RESPONSE TO SUBMISSIONS: WOOLWORTHS WAREHOUSE AND DISTRIBUTION CENTRE AUBURN MODIFICATION 1 (SSD-10470-MOD-1)

11 AND 13 PERCY STREET, AUBURN
LOT 1 AND 2 DP1183821

3 February 2022

FIGURE 3. REVISED PLANT AREA LAYOUT (SOURCE: NETTLETON TRIBE, 2022)

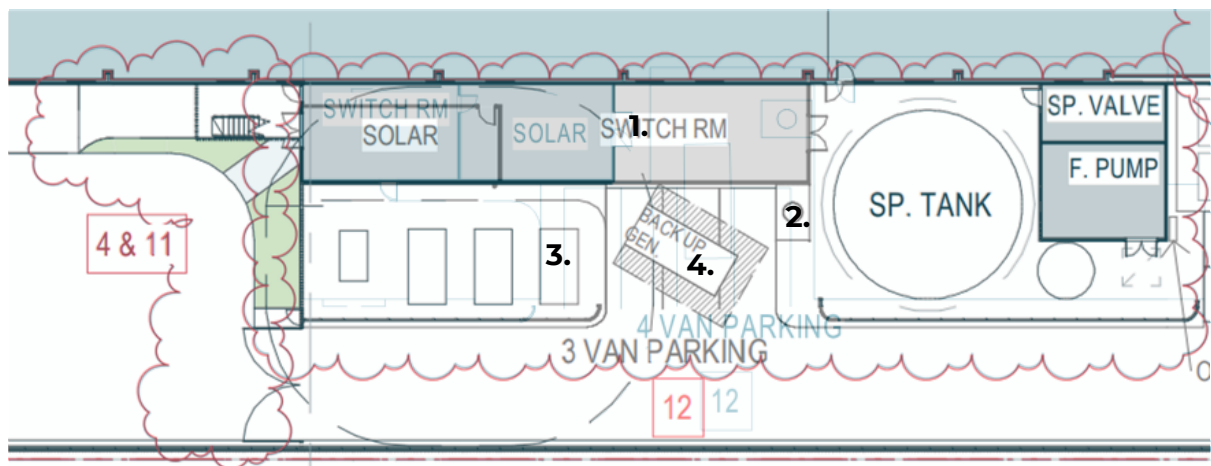
As shown below (previous proposal shown in blue underneath), the key differences include:

1. The layout and size of the solar and switch rooms;
2. The relocation of the diesel storage tank;
3. The HV infrastructure area has been amended to include an additional HV compartment, as required by Ausgrid (note: 2 of the 4 rectangles represent the substations); and
4. The location/orientation of the backup generator – this is a temporary (portable) backup generator, which will only be imported to site in the event that it is required.
